Form 3160-5
(June 2019)UNITED STATES
DEPARTMENT OF THE INTERIOR
BUREAU OF LAND MANAGEMENTFORM APPROVED
OMB No. 1004-0137
Expires: October 31, 2021**SUNDRY NOTICES AND REPORTS ON WELLS**
Do not use this form for proposals to drill or to re-enter an abandoned well. Use Form 3160-3 (APD) for such proposals.5. Lease Serial No. **MULTIPLE**6. If Indian, Allottee or Tribe Name
MULTIPLE**SUBMIT IN TRIPLICATE - Other instructions on page 2**

EOG Resources Inc. (EOG) respectfully requests the execution of the variance for Wellhead break testing and offline cementing for the following wells, as outlined below (and with the additional Offline Cement Intermediate Operational Procedure):

Ross Draw 17 Fed Com Batch

Revised Permit Information 06/08/2022:

Revised Wellbore

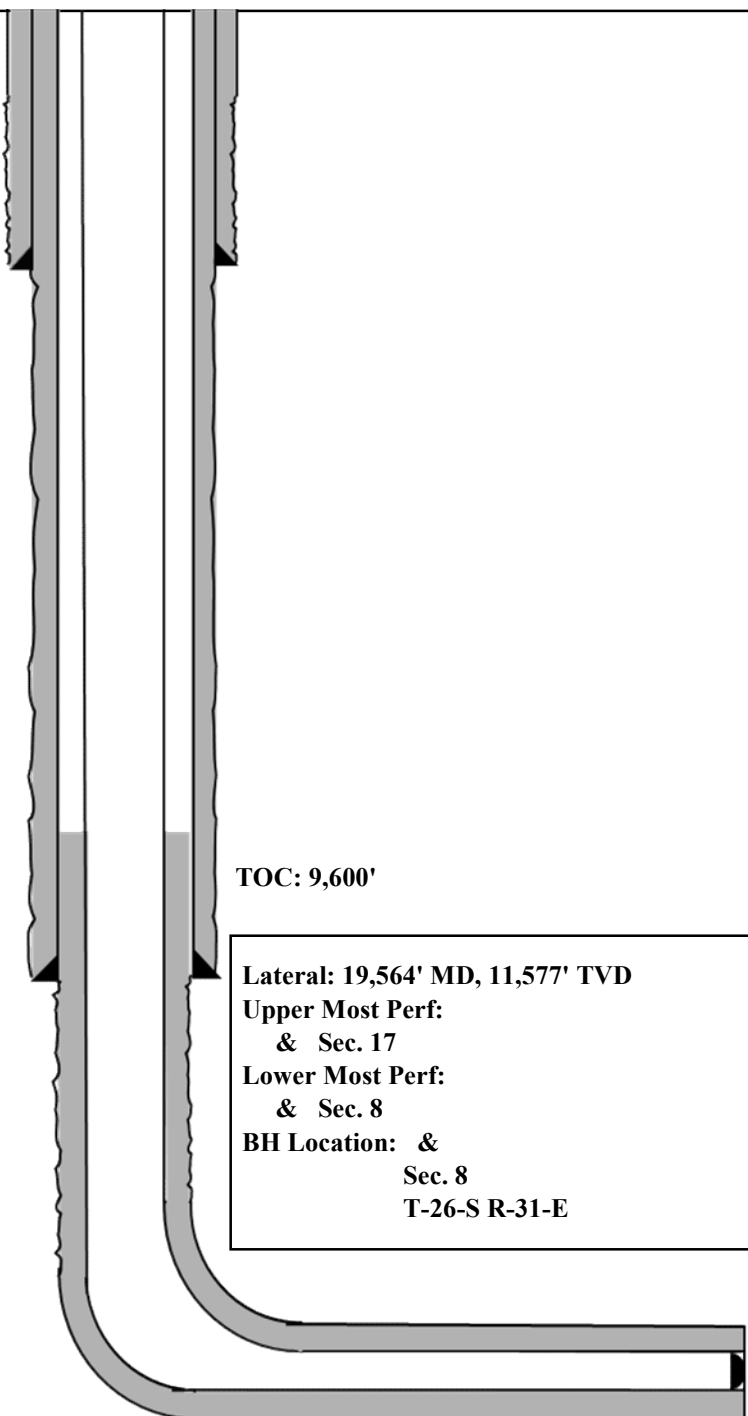
EOG also requests the surface casing change from 40# to 36#, and the curve/lateral production hole size changed to 6-3/4" (from 8-1/2" taper).

Bit Size: 12-1/4"
 9-5/8", 36#, J-55, LTC,
 @ 0' - 1,310'

Bit Size: 8-3/4"
 7-5/8", 29.7#, HCP-110, FXL,
 @ 0' - 10,100'

Bit Size: 6-3/4"
 5-1/2", 20#, P110-EC, DWC/C IS MS,
 @ 0' - 9,600'

5-1/2", 20#, P110-EC, Vam Sprint SF,
 @ 9,600' - 10,100'

5-1/2", 20#, P110-EC, DWC/C IS MS,
 @ 10,100' - 19,564'
